MEMORANDUM

February 7, 2014

TO: County Council
FROM: ^{GO} Glenn Orlin, Deputy Council Administrator
SUBJECT: **Worksession/Action**—Bethesda Purple Line Station Minor Master Plan: transportation issues

Figure 4: Capital Crescent Trail without Redevelopment

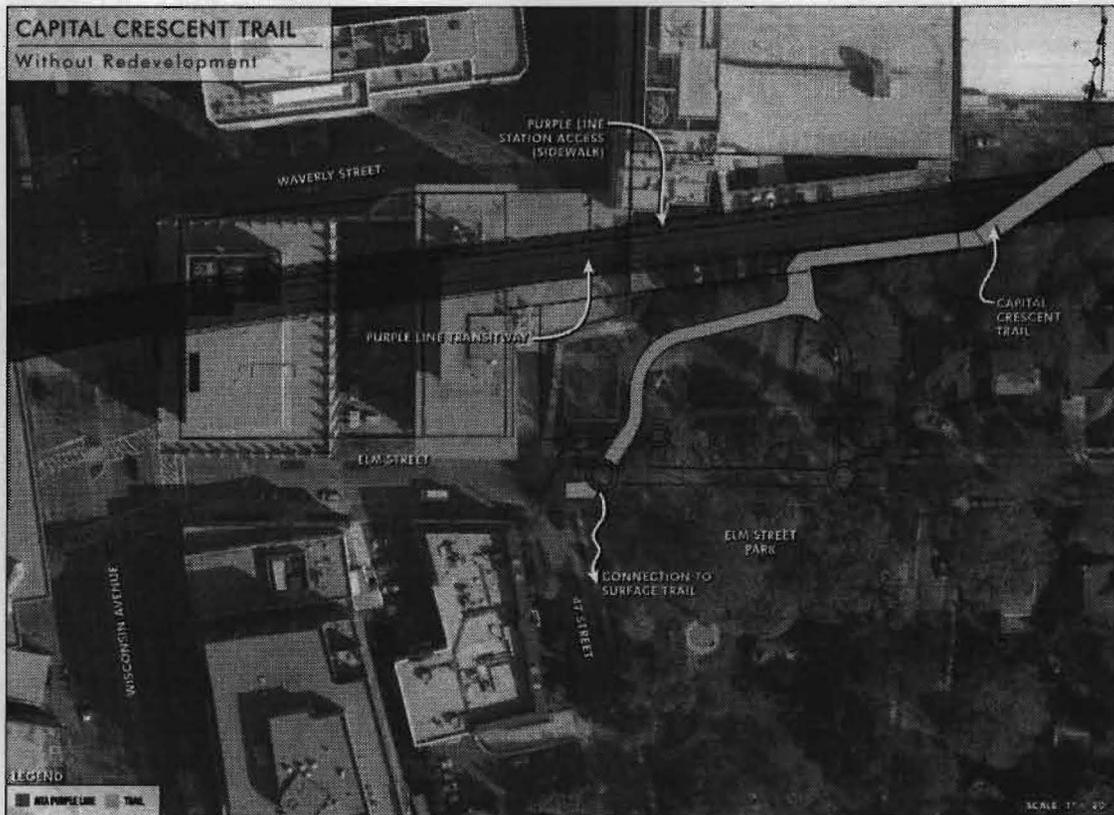
As noted above and illustrated in Figure 4 below, the current plan is for the Capital Crescent Trail is to utilize the Surface Route as the main connection through downtown Bethesda. Heading in the westbound direction the Capital Crescent Trail crosses over the Purple Line and winds through the northern portion of Elm Street Park. It then transitions into the Surface Route, traveling southbound along the east side 47th Street, heading westbound along the south side of Willow Lane, crossing Wisconsin Avenue, and then heading westbound along the north side of Bethesda Avenue. A narrow 5 to 7 foot wide sidewalk would provide access from the Capital Crescent Trail directly into the Purple Line station, running adjacent to the Purple Line, but would be prohibited for bicycles due to space limitations. The benefits of a new tunnel should be weighed against this Baseline condition.

Parking Lot Entrance to 4610 Elm Street

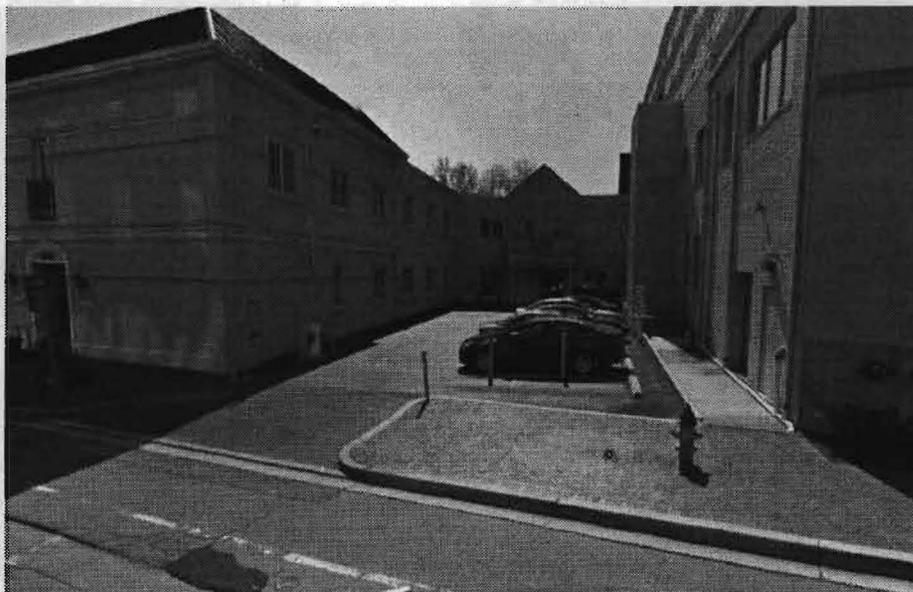
- **Tunnel Grade:** Perhaps the most important design consideration for Option 1 is the 8% grade over a distance of 225 feet that is needed to avoid cutting off access to the parking lot for 4610 Elm Street (see below). An 8% grade is very steep and would be difficult – if not impossible – for

several user groups to navigate, including children, elderly, and disabled users. An elevator at the southeast corner of Wisconsin Avenue and Elm Street would provide an ADA compliant alternative route. An 8% grade could be an issue because: 1) it would allow cyclists traveling downhill toward the Purple Line station to reach high speeds on their bikes, and 2) because cyclists traveling uphill typically need additional space to navigate steep grades and could come in contact with other trail users if the trail is only 13 feet wide. Many trail users may opt instead to cross Wisconsin Avenue at grade using the Surface Route or at Elm Street to avoid the tunnel. Tunnel Option 2 has a segment of about 150 feet that has a grade of 4.75%. While this is still steep, it meets ADA requirements and is much more reasonable for various user groups to navigate.

16 feet and if the grade can be reduced to below 5 percent, Option 1 would become an excellent connection and would justify the costs. At this time it appears the only way to reduce the grade of the trail without major impacts to Elm Street Park is to close the commercial driveway on the south side of Elm Street and relocate the 10 parking spaces somewhere else. In the longer term, with redevelopment, it may be possible to eliminate the parking lot altogether.

Intersection of Wisconsin Avenue / East-West Highway / Old Georgetown Road

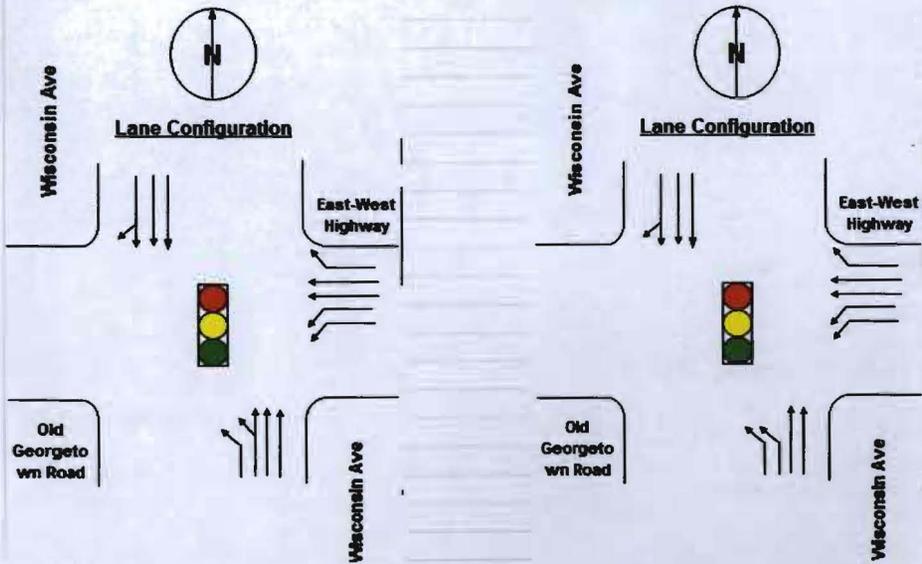
At two other intersections, the standard can be met merely by reassigning how the existing lanes are used. At Wisconsin Avenue/East-West Highway/Old Georgetown Road, the intersection is forecasted to operate at 1.20 and 1.22 v/c in the AM and PM peaks, respectively. Currently the northbound approach on Wisconsin Avenue has an exclusive left-turn, a combination left/through-lane, and two through lanes. If the combination left/through lane were to be designated as a second left-turn lane, then the v/c ratios would improve to 1.05 and 0.97, respectively.

This intersection is below the 1800 CLV standard for the Bethesda CBD in all scenarios, but in the 2040 Master Plan High Estimate scenario it exceeds the 1.13 HCM standard during the AM and PM peak hours. To bring this intersection within an acceptable level of congestion would require:

- Converting the existing northbound left/through lane to a left lane

(1) Northbound Direction: Revise lane configuration from Left, Left/Through, Through, Through to Left, Left, Through, Through

Intersection of Wisconsin Avenue / Bradley Blvd

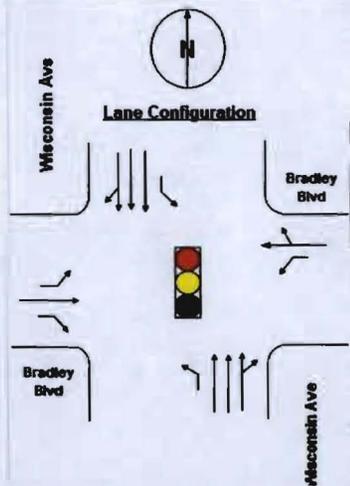
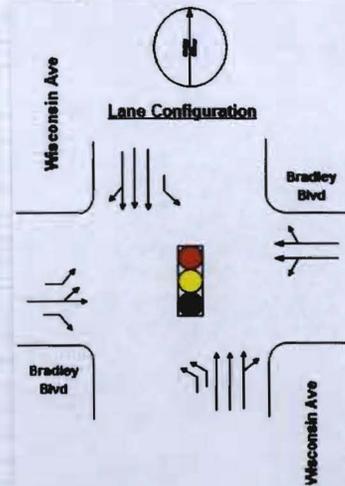
The only intersection widening identified by the analysis would be on the south leg of Wisconsin Avenue at Bradley Boulevard, where a second northbound-to-westbound left-turn would be needed to bring the intersection in compliance with the 1.13 v/c standard. This would mean adding 10' to the road's cross-section: perhaps 5' from each side (abutting the fire station to the west and the Chevy Chase Club to the east).

This intersection is below the 1800 CLV standard except in the 2040 Master Plan High Estimate during the PM peak hour and the 1.13 HCM standard in all future scenarios for the AM and PM peak hours. To bring this intersection within an acceptable level of congestion would require:

- Add a second northbound left turn lane
- Converting the existing eastbound through lane to a left/through lane
- Converting the existing westbound left lane to a left/through lane

(1) Northbound Direction: add 2nd left turn lane

Eastbound Direction: Revise lane configuration from Left, Through, Right to Left, Left/Through, Right

Westbound Direction Revise lane configuration from Left, Through/Right to Left/Through, Through/Right

Intersection of Bradley Blvd / Arlington Road

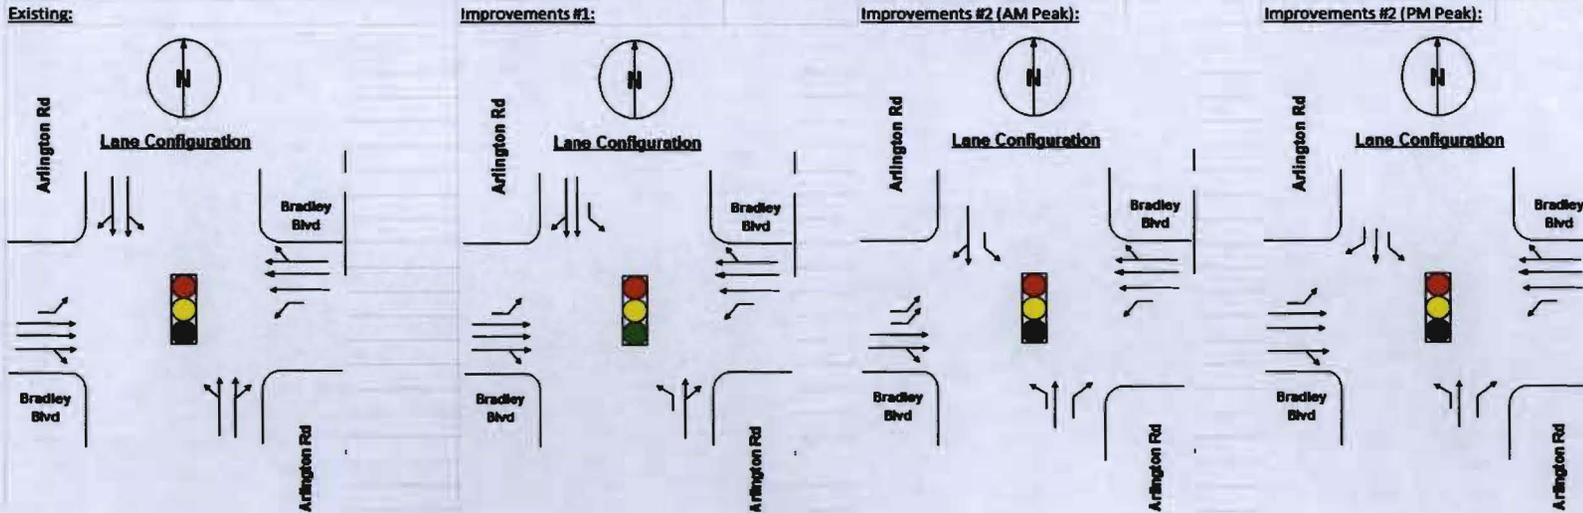
Bradley Boulevard/Arlington Road is forecasted to operate at 1.17 and 1.71 v/c in the AM and PM peaks, respectively. Here the solution is dynamic lane assignment: changing how some of the lanes on the northbound and southbound approaches on Arlington Road are utilized between the AM and PM peaks. With the reassignment, the v/c ratios would improve to 1.08 and 1.13, respectively.

This intersection is below the 1800 CLV standard in all scenarios. It exceeds the 1.13 HCM standard for the PM peak hour in the existing scenario and the AM and PM peak hours in all future scenarios. To bring this intersection within an acceptable level of congestion would require:

- Convert the existing southbound left/through lane into a through lane and add a left turn lane

(1) Southbound Direction: Revise land configuration from Left/Through, Through/Right to Left, Through, Through/Right

(2) Dynamic Lane Use:

Southbound Direction: AM peak lane configuration is left, through/right; PM peak lane configuration is left, through, right

Eastbound Direction: AM peak lane configuration is left, left, through, through/right; PM peak lane configuration is left, through, through, through/right
